Product / Process Change Notification (PCN)

PCN #: PCN_IndCMBNC_20191209

Affected Series: WE-CMBNC-Series;
 P/N: 7448053201, 7448051804, 7448052502,
 7448051012, 7448050530

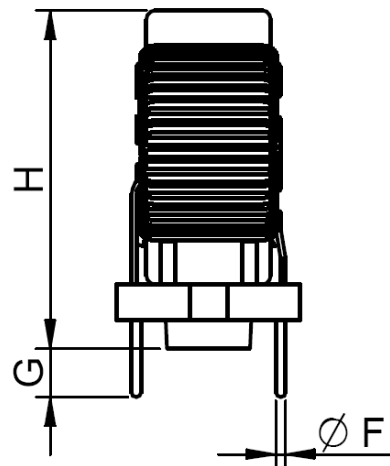
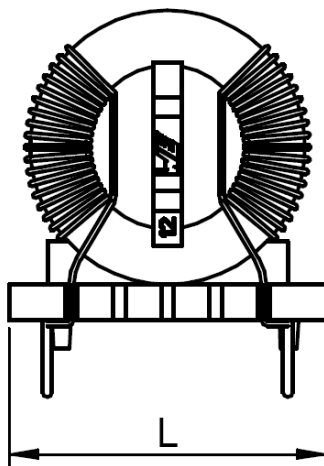
Because of a database mismatch, Würth Elektronik will correct the specified maximal height of the parts. This is a datasheet correction only. There will be no change in form, function, quality or reliability of the product.

We are correcting the dimension "H" of the product in our data sheet:

Part number	Dimension "H" before change [mm]	Dimension "H" after change [mm]
7448053201	36 max.	34 max.
7448051804	36 max.	34 max.
7448052502	36 max.	34 max.
7448051012	36 max.	33 max.
7448050530	36 max.	33 max.
